6674A-09A

S E R V I C E N O T E

6674A DC POWER SUPPLY GPIB CONTROLLED

The Current Shunt (Circuit Reference “R907”) may have intermittent sense wires, which may cause Instability of Current regulation, Current read back and current programming.

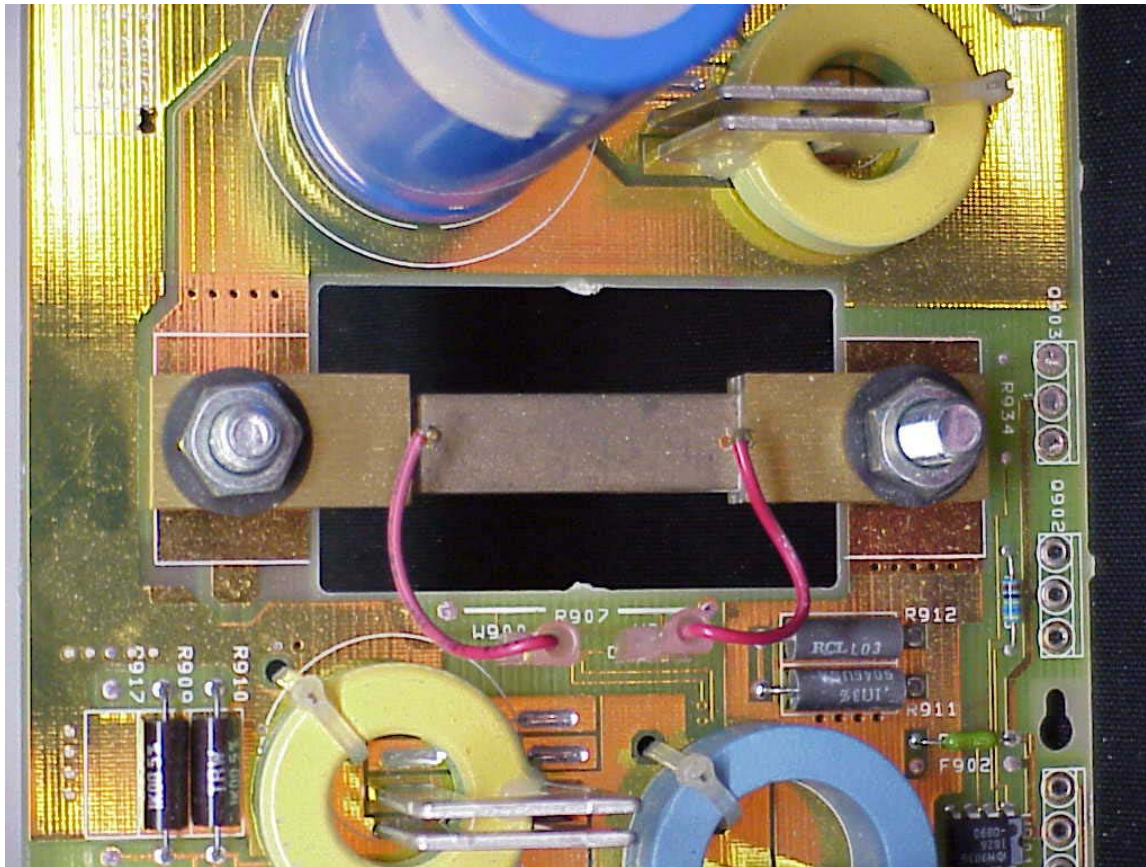
When the push-on connectors become intermittent the output current will become unstable. Loose push-on connectors can cause the output current to change dramatically. The current can change from any set current, and may go to the maximum rated output current of the instrument.

This picture shows how the Shunt R907 is connected using the term-crimp connectors. The Shunt R907 is connected to "W900" & "W901"

Cut the terminal-crimp connectors off of both wires and discard the connectors. Make this cut as close to the terminal-crimp connector as possible. The required strip length should be 5mm. This strip length will be used to prevent the wire length being too long and shorting to the instrument chassis. If replacement of this wire is required any color (22 AWG. 300V 105C) wire type can be used.

This modification can be done from the top of the board. Carefully strip and solder the wires, and avoid burning the wire insulation and the printed circuit board.

The wires should be connected as shown below. There are two holes marked R907 that should be used. Do not cross the wires when making this modification. See picture below for details. This picture shows the required modification.
